ADDENDUM NO. 1
January 28, 2026

Arbor Valley Phase II Improvements
Valley Center, KS

From: Short Elliott Hendrickson Inc.
15750 Dodge Rd, Suite 304 Omaha, NE 68118

Issue:		
1	ISSUED FOR CONSTRUCTION	03/10/21
JOB NO.	217013-001	
DATE	10 MARCH 2021	
PM	JAG	
DESIGNED BY	JAG	
DRAWN BY	DSB	
CHECKED BY	MEB	
CONCRETE PAVEMENT AND JOINTING DETAILS		
C-502

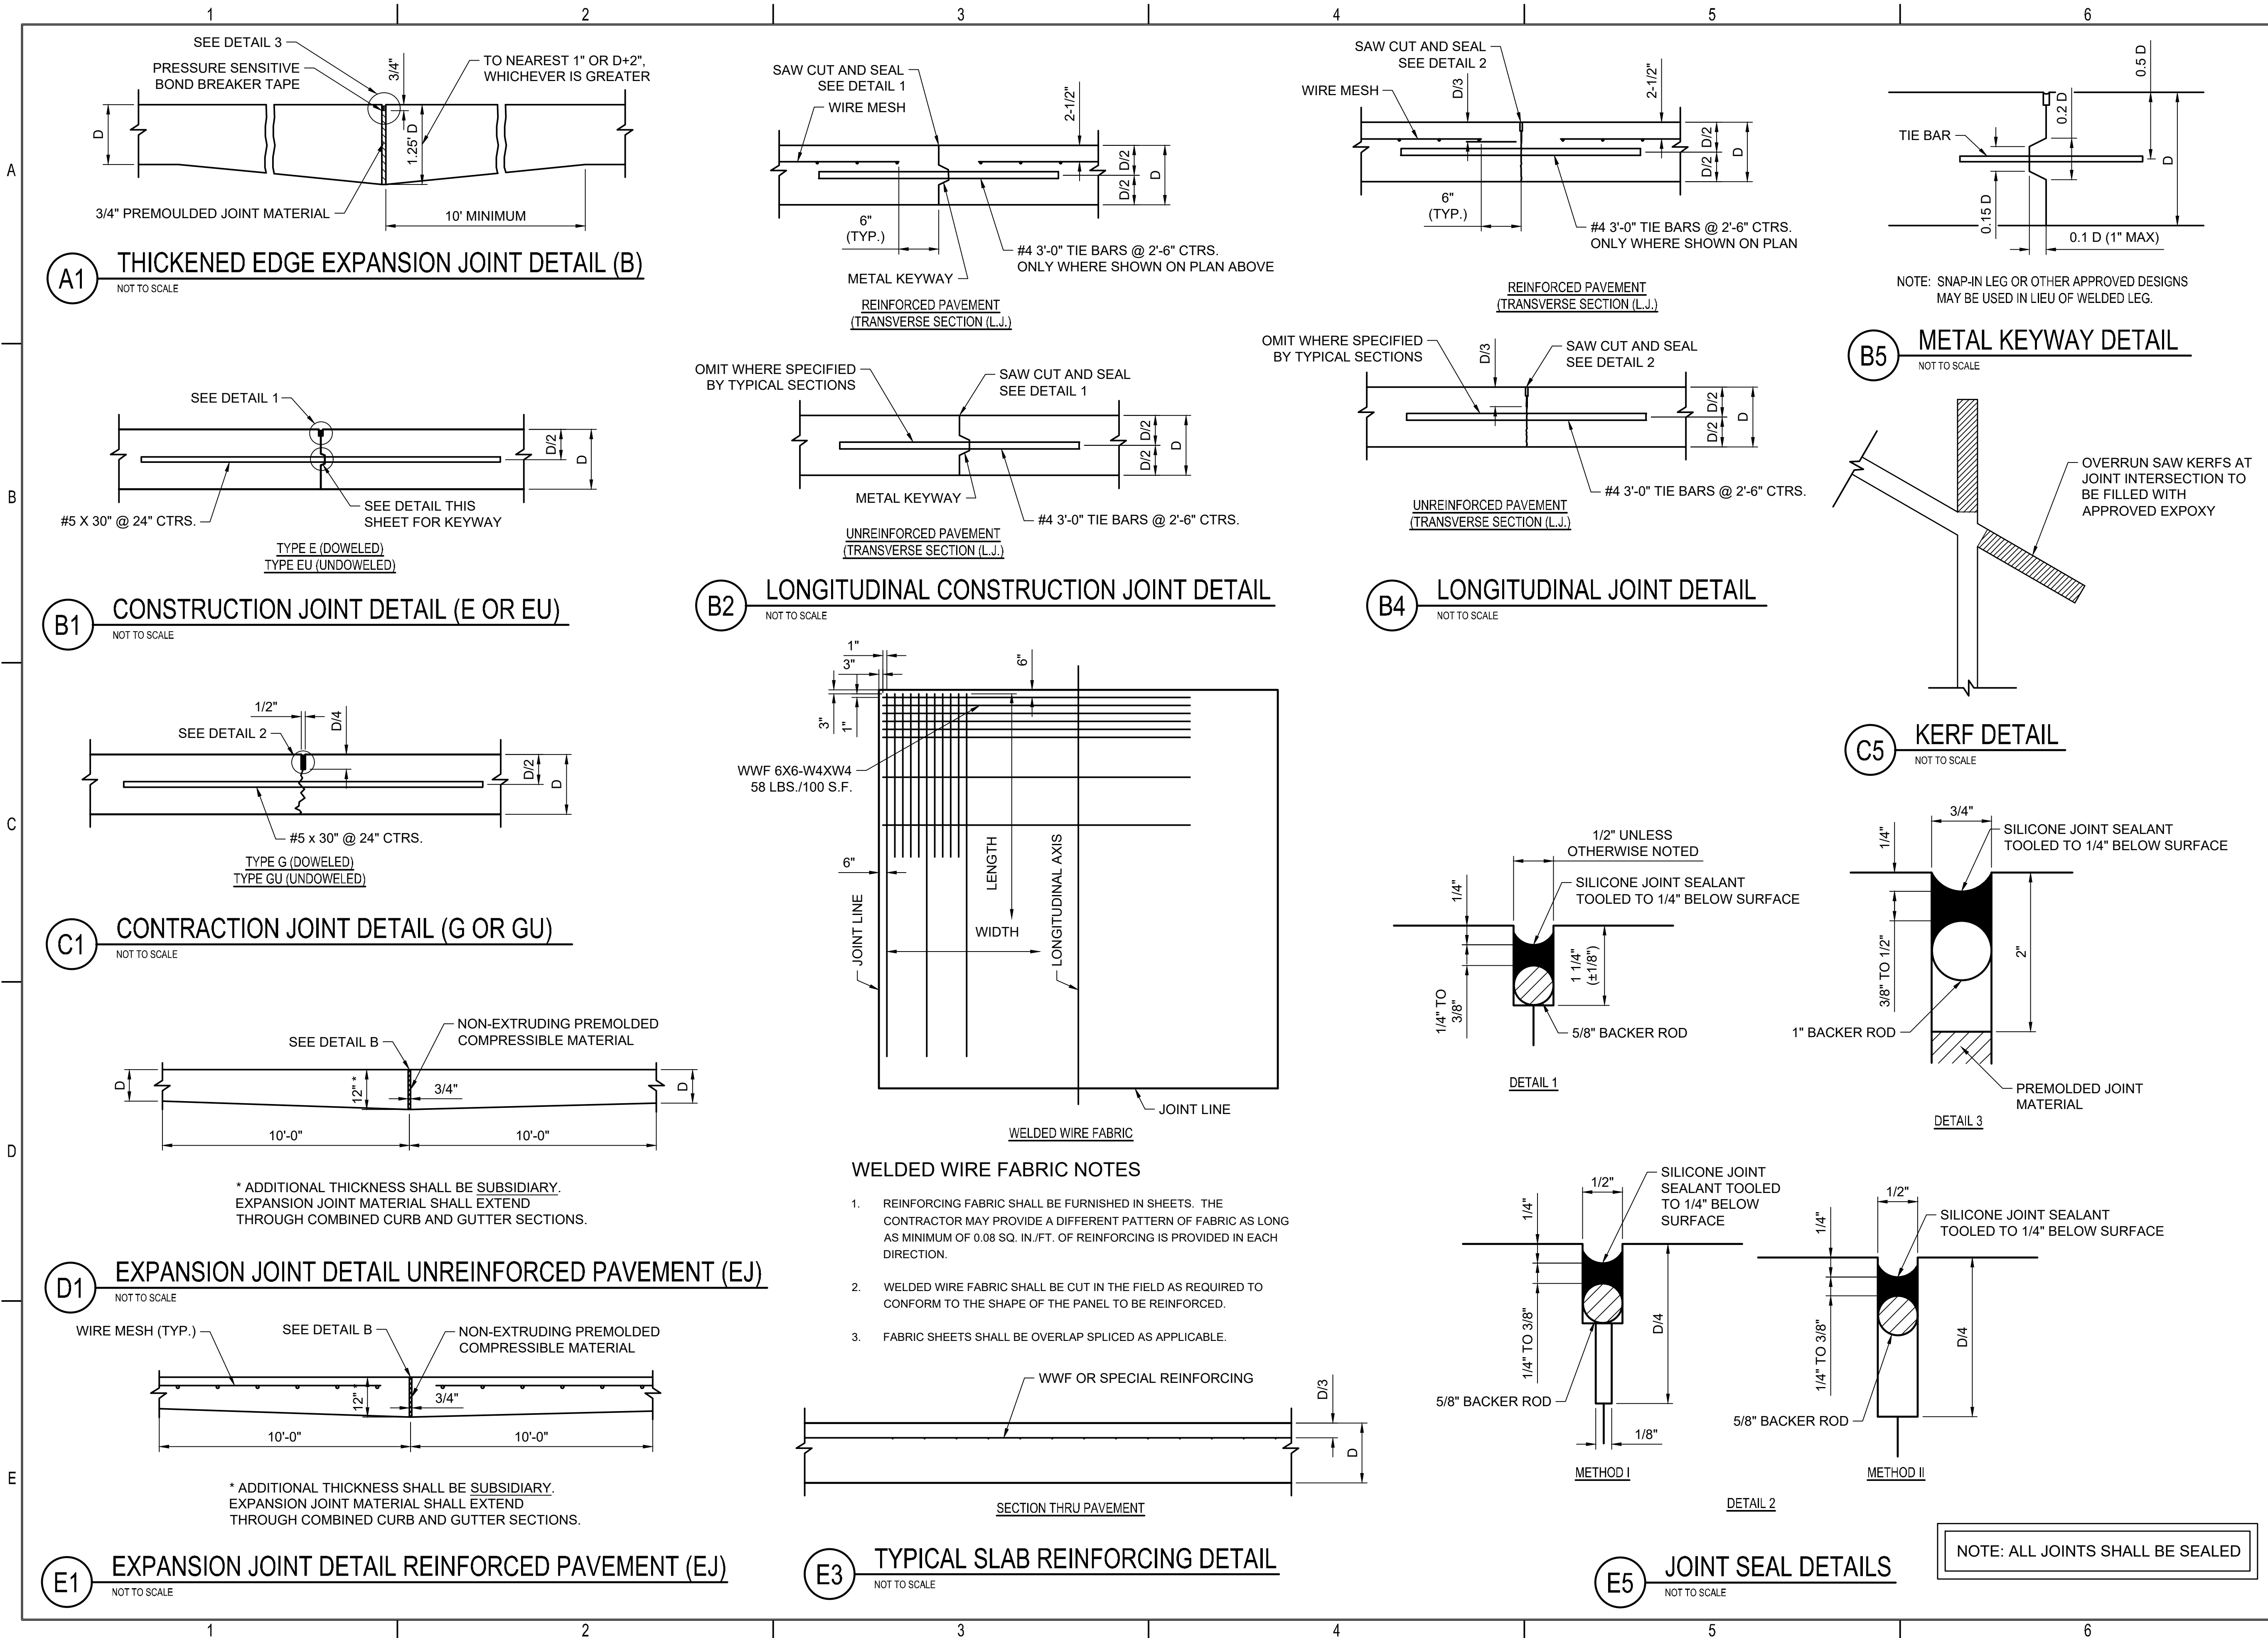
3. Sheets 30-43 of the plans are attached for reference.
4. The 'Thickened Edge Connection' shall follow the detail on sheet C-502, Detail D1 (no expansion material).
